Access Compliance Report

Public Rights-of-Way

Intersection ID: 46749	Main Street: NORMANS_LANDING_DR	Cross Street: HAVASU_ST	Location: SE
ADA ID: 775759CDCE69	Ramp Type: PerpDiag	Initial Pass/Fail: Fail	Overall Compliance: No
			Severity Score: 21.25

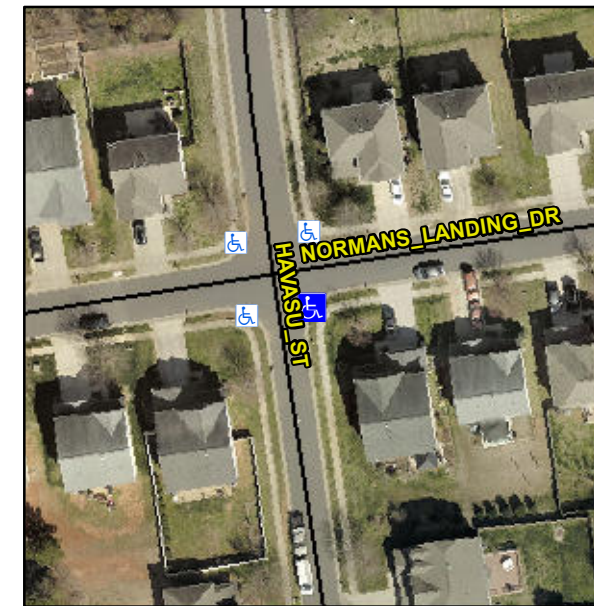
Not Found, R304.5.1, R304.5.3

Compliance	Description	Data	Compliance	Description	Data
N/A	Ramp Length (in)	47.0	Yes	Ramp Slope (%)	5.8
No	Ramp Width (in)	45.5	No	Ramp XSlope (%)	6.6
N/A	Flare Type LT	N/A	N/A	Flare Type RT	N/A
N/A	Flare Slope LT (%)	N/A	N/A	Flare Slope RT (%)	N/A
N/A	Flare Traversable LT?	N/A	N/A	Flare Traversable RT?	N/A
N/A	Landing Length (in)	N/A	N/A	DWS Provided?	N/A
N/A	Landing Width (in)	N/A	N/A	DWS Contrast?	N/A
N/A	Landing Slope (%)	N/A	N/A	DWS Length (in)	N/A
N/A	Landing X Slope (%)	N/A	N/A	DWS Full Width?	N/A
N/A	Landing Curb? (Y/N)	N/A	N/A	DWS Offset (in)	N/A
N/A	Shared Landing?	N/A			
N/A	Gutter Ponding?	N/A	N/A	Gutter Slope (%)	N/A
N/A	Gutter Lip Ht (in)	N/A	N/A	Gutter X Slope (%)	N/A
N/A	Painted X Walk1?	No	N/A	Painted X Walk2?	No
	X Walk 1 Direction	To N		X Walk 2 Direction	To W
N/A	X Walk 1 Width (in)	N/A	N/A	X Walk 2 Width (in)	N/A
	X Walk 1 Slope (%)	0.7		X Walk 2 Slope (%)	7.8
	X Walk 1 X Slope (%)	7.4		X Walk 2 X Slope (%)	2.8

Remove & Replace Curb Ramp With Two New Directional Ramps or Equivalent.
